Amendment 0002
Solicitation Number: ONRBAA11-028
“Large Displacement Unmanned Underwater Vehicle Innovative Naval Prototype
(LDUUV INP) Energy Section Technology”
Date: (4 AUG 2011)

The purpose of Amendment 0002 is to amend the BAA and respond to questions submitted prior to 15 AUG 2011. Section IV, “Application and Submission” is revised to reflect changes to the instructions for submitting technical and cost proposals for this BAA. Table 2, “Desired Metrics” has been replaced. Enclosure Number 1 to Amendment 0002 entirely replaces/supersedes the original ONRBAA11-028 previously posted.

Large Displacement Unmanned Underwater Vehicle Innovative Naval Prototype (LDUUV INP) Energy Section Technology

Figure 1. Vehicle Hull Section

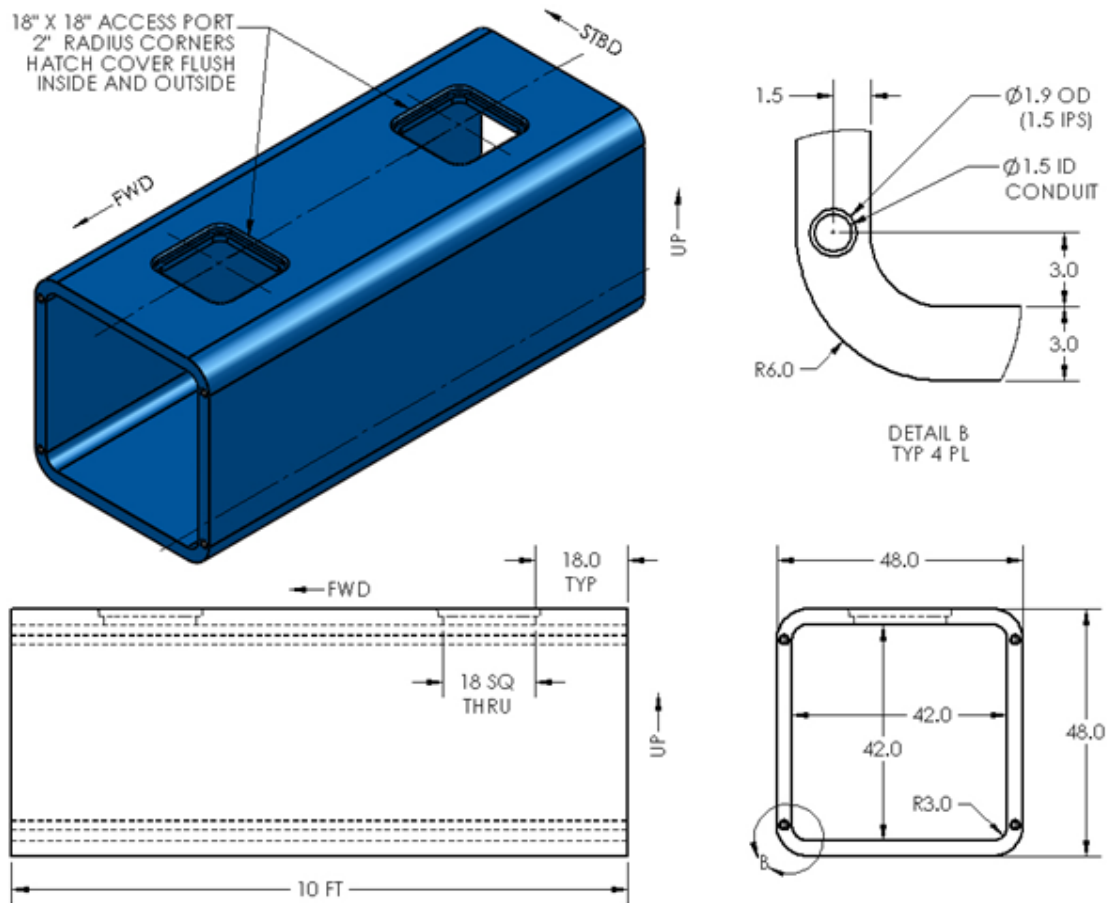
Question 6:

Can the vehicle hull section described in Figure 1 be designed by the contractor to act as a pressure vessel?

Answer 6:

Please see Table 1 and Figure 1 (and their notes) of ONRBAA 11-028.

Figure 3: Objective Mission Profile
(Data available in Appendix A)

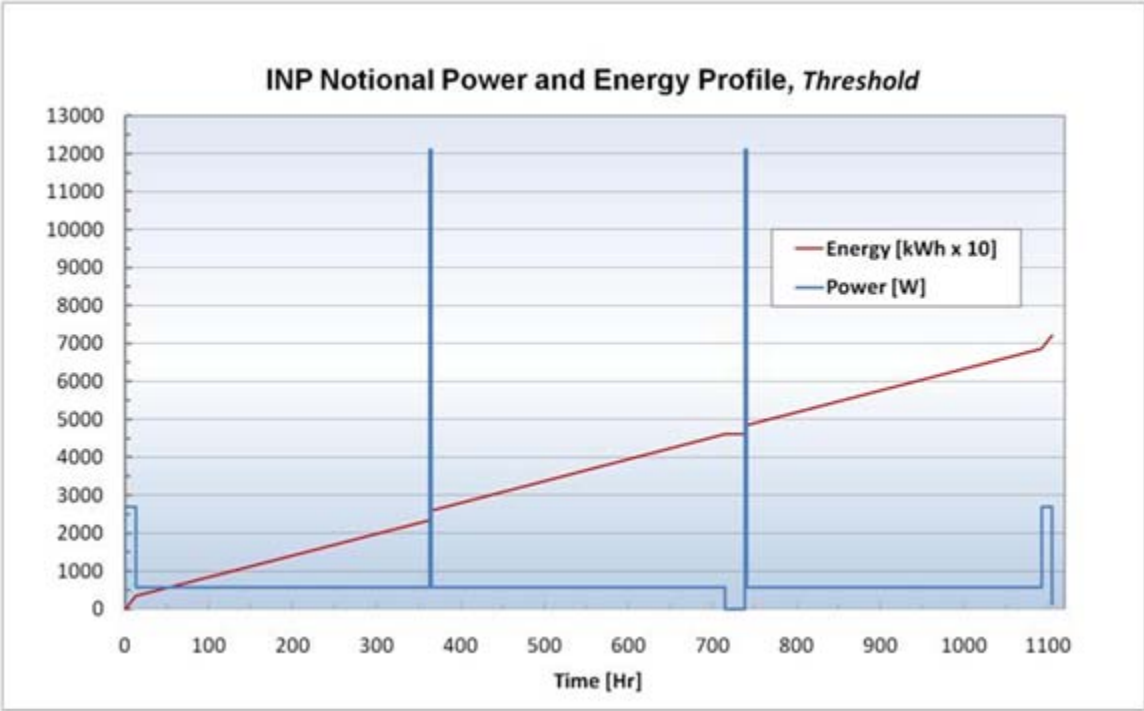
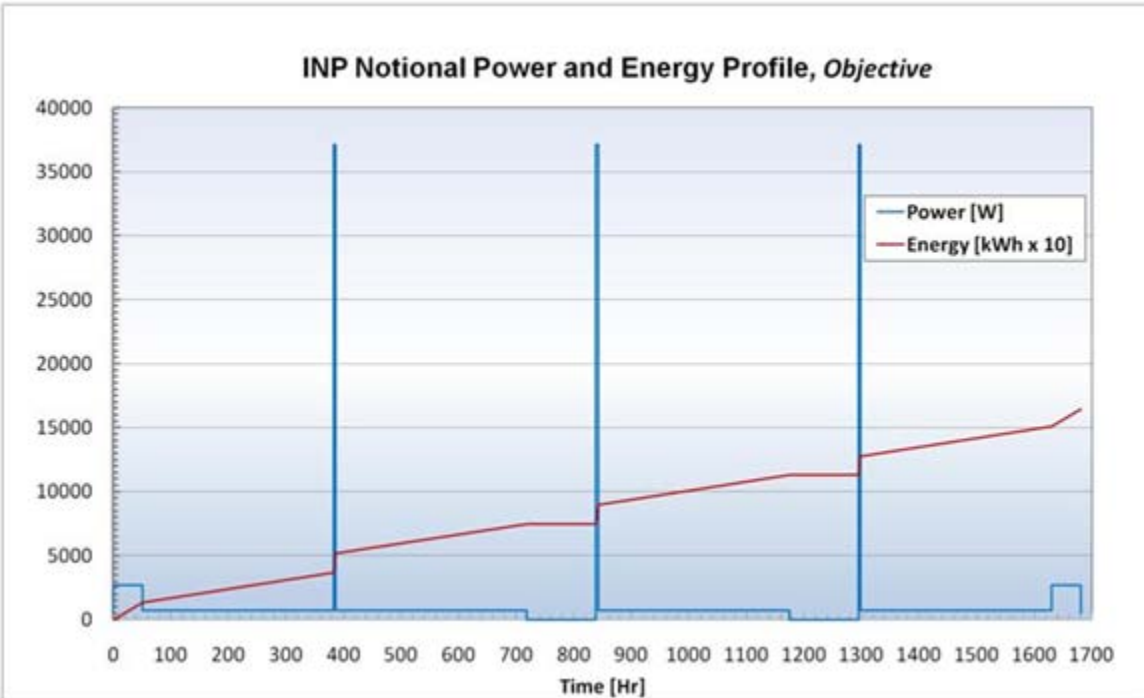
Question 7:

Page 6. Table 2 Hibernation Cycle: Is there an expected duration of the hibernation cycle? Do the hibernation cycles coincide with the two ~100 hour zero power level periods in Figure 3?

Answer 7:

Reference Figure 2, Figure 3 and Appendix A Power Profile. Hibernation periods are those times during which Power is 0 Watts.
